## ELM CREEK PRO JZ22-28

**ELM CREEK PRO JZ22-28 WITH REZONING 18.737**

Public hearing at the request of Toll Brothers, Inc. for revised initial submittal and eligibility discussion for a Zoning Map amendment from Office Service Technology (OST) and Low-Rise Multiple Family (RM-1) to Low-Rise Multiple Family (RM-1) with a Planned Rezoning Overlay. The subject site is approximately 37-acres and is located south of Twelve Mile Road, west of Meadowbrook Road (Section 14). The applicant is proposing to develop a two-phase 134-unit multiple-family townhome development.

## PLANNING REVIEW

**GRADING PLAN - PHASE 1**

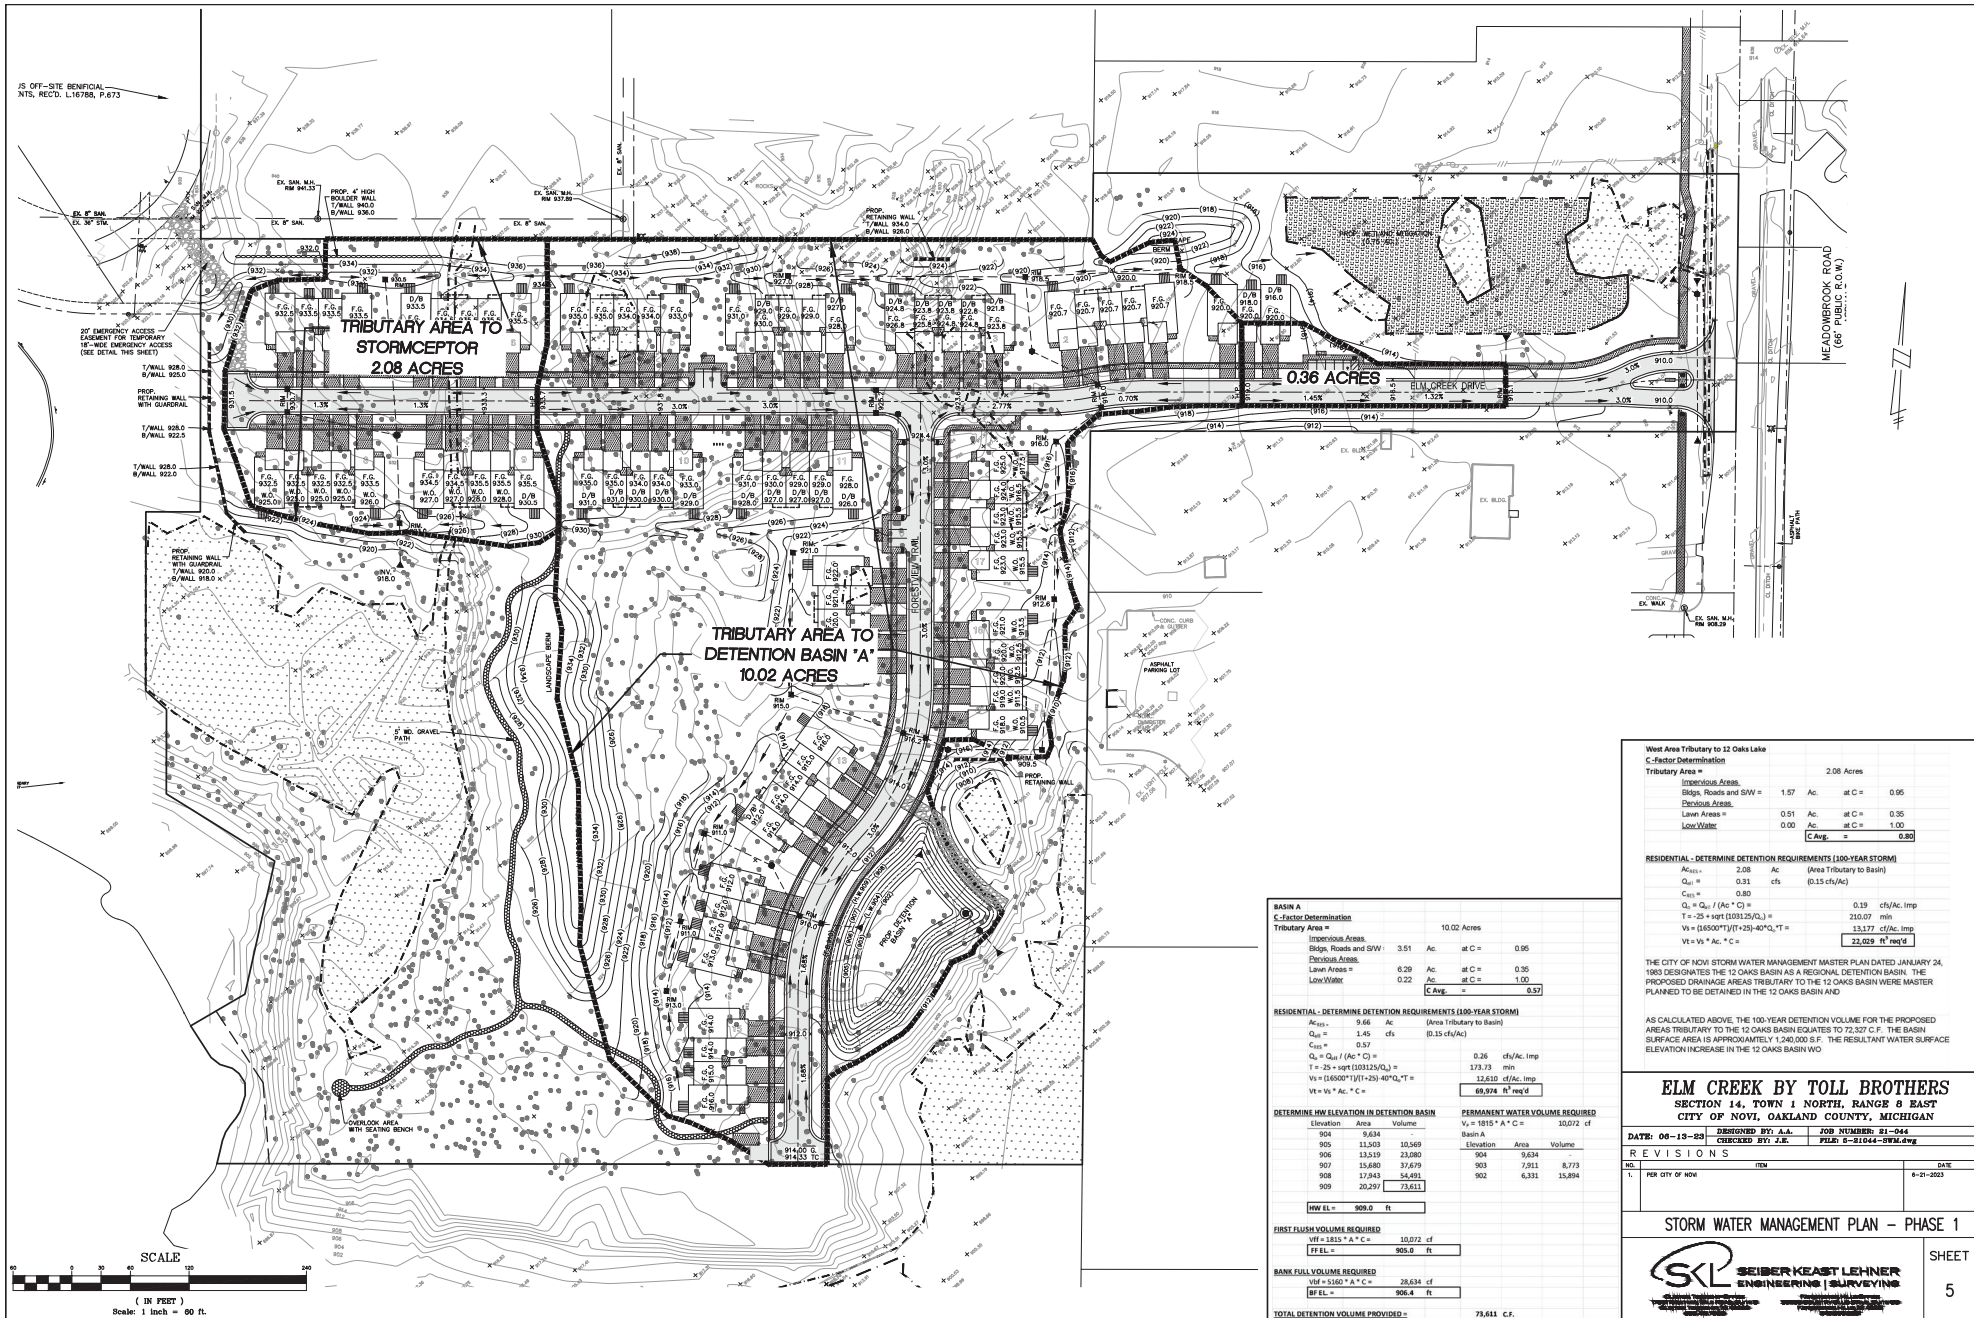
38. The contour lines on plan Sheet 4 shows different elevations than Sheet 5 (south side of the property). It appears Sheet 4 is correct.
39. Provide at least 3-foot of buffer distance between the sidewalk and any fixed objects, including hydrants and irrigation backflow devices. Include a note on the plan where the 3-foot separation cannot be provided.
